SERVICE BULLETIN

Number: ___13-002_

Ford 5.4L / 6.8L Mount Kit Safety Recall

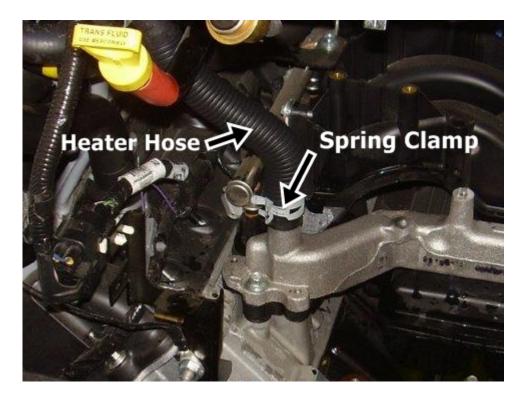
Trans/Air has become aware of isolated instances where, during the installation process, the alternator harness has become pinched between the mount plate and the heater hose spring clamp tangs at the front of the manifold. This condition could cause the harness wires to be cut, which could cause a short circuit and ignition point. Trans/Air Manufacturing is issuing a Safety Recall thru Service Bulletin #13-002, to address this concern.

Cause: If the tab from the heater hose spring clamp is not oriented

properly, (toward the rear of the engine) it could possibly pinch the

alternator cable against the compressor mount plate.

Corrective Action: If the harness is pinched, move harness to a location that is clear of

spring clamp and rotate the tangs of the clamp to the rear of the

engine (See pictures below)
